Generic Environmental Impact Statement for License Renewal of Nuclear Plants

Supplement 38

Regarding Indian Point Nuclear Generating Unit Nos. 2 and 3

Draft Report for Comment

Figure 4-3. Percentage of entrainment composed of RIS fish and total identified fish relative to the estimated total entrainment at IP2 and IP3 combined (data from Entergy 2007b)

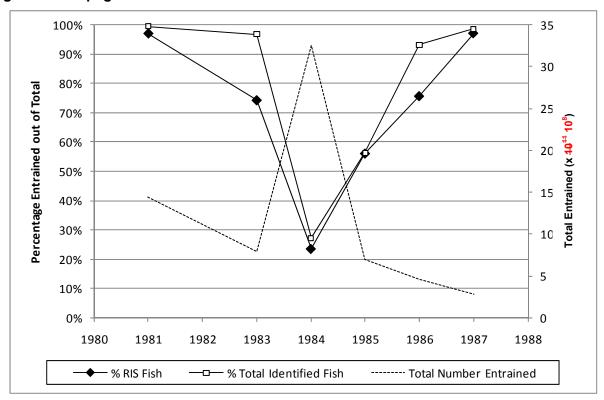
- entrainment catch density directly affects Figure 4-3 in Section 4.1.2, and the error is repeated
- in Figure H-5 in Appendix H. In these figures, the total number entrained on the right axis

- should be in units of numbers \times 10⁸ instead of numbers \times 10¹¹. The corrected
- 21 Figures 4-3 and H-5 appear below. In addition, these changes affect two portions of text in the

Figure 4-3 on page 4-15 in the FSEIS is corrected as follows:

Figure H-5. Percentage of entrainment composed of RIS fish and total identified fish relative to the estimated total entrainment at IP2 and IP3 combined (data from Entergy 2007b)

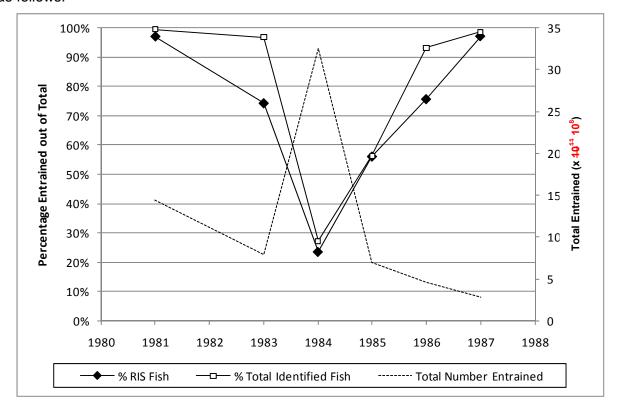
Figure H-5 on page H-23 in the FSEIS is identical to Figure 4-3 in the FSEIS and is corrected as follows:
